UNITED STATES PATENT AND TRADEMARK OFFICE

10/688,365

Office Action Summary	Application No. 10/688,365	Applicant(s) FORSBERG, ANDREW THOMAS	
	Examiner JING OU	Art Unit 3773

DETAILED ACTION

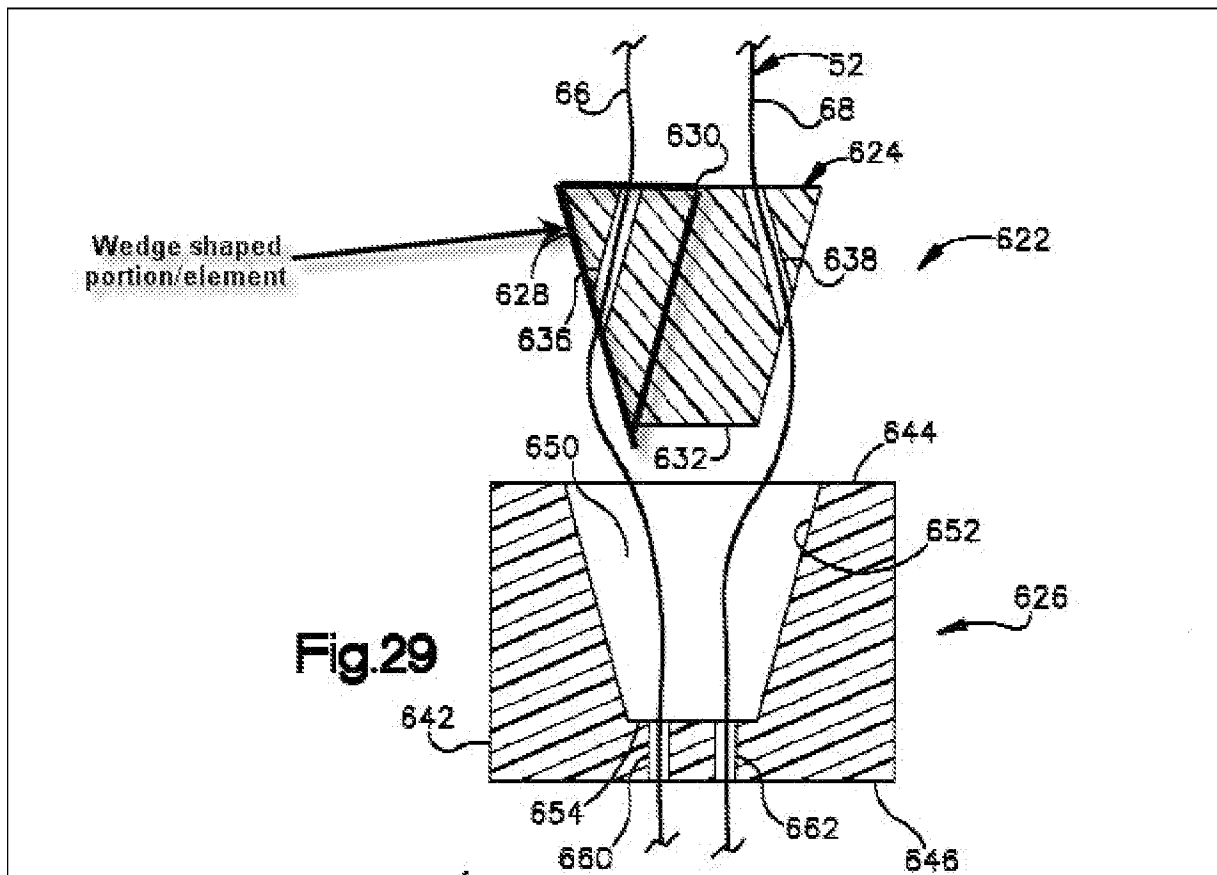
In addition, Bonutti et al teaches a system comprising: a housing (**626**), a channel (**636 and 660**); and a suture locking mechanism including a wedge shaped portion/element (see Figure below and Col. 32, lines 25-29, wedge is defined to be “any shape that is triangular in cross section” or “a piece of anything of like shape”); wherein the locking mechanism changes from the non-locking position to the locking position by sliding movement (Col. 32, lines 30-67); wherein the wedge shaped portion of the locking mechanism is spaced apart from the housing (Fig. 29); wherein wedge shaped
